Product Advisory (PA)

Subject: Transfer of the Final Test, Visual Inspection and Packing production line for MCU products

Packing Specification

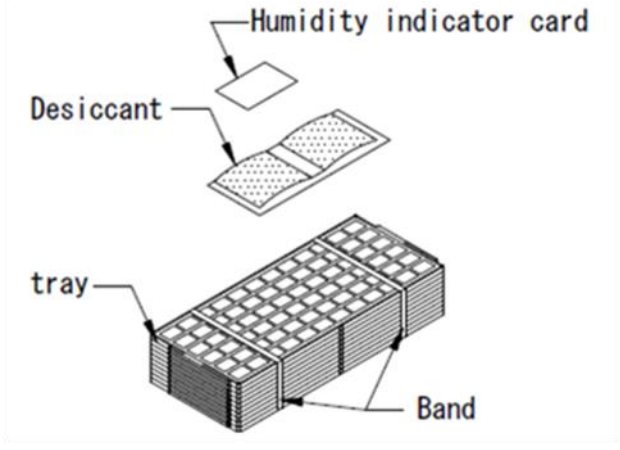
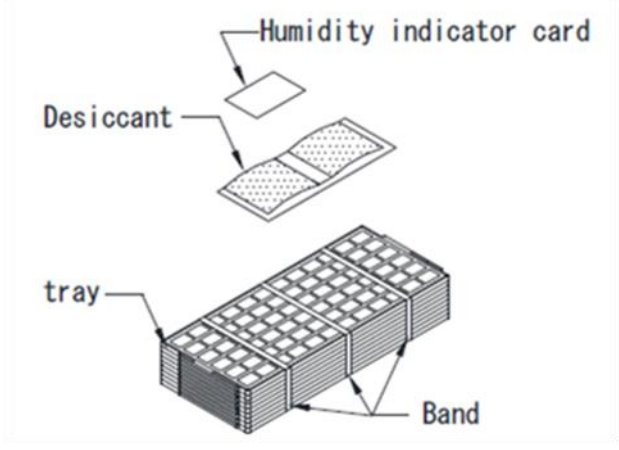
The packing specification of BGA products, LQFP product (Not applicable for JEDEC) will be changed (Change from 2 bands to 3 bands, see the following figures).

【Current】 Final Test:Yonezawa	【Post】 Final Test:Tera Probe
 The diagram shows a 3D perspective of a rectangular tray filled with a grid of square components. Two vertical bands are visible, dividing the tray into three sections. Above the tray, a rectangular humidity indicator card is shown, and below it, a desiccant packet is depicted. Labels with arrows point to the 'Humidity indicator card', 'Desiccant', 'tray', and 'Band'.	 The diagram shows a 3D perspective of a rectangular tray filled with a grid of square components. Three vertical bands are visible, dividing the tray into four sections. Above the tray, a rectangular humidity indicator card is shown, and below it, a desiccant packet is depicted. Labels with arrows point to the 'Humidity indicator card', 'Desiccant', 'tray', and 'Band'.
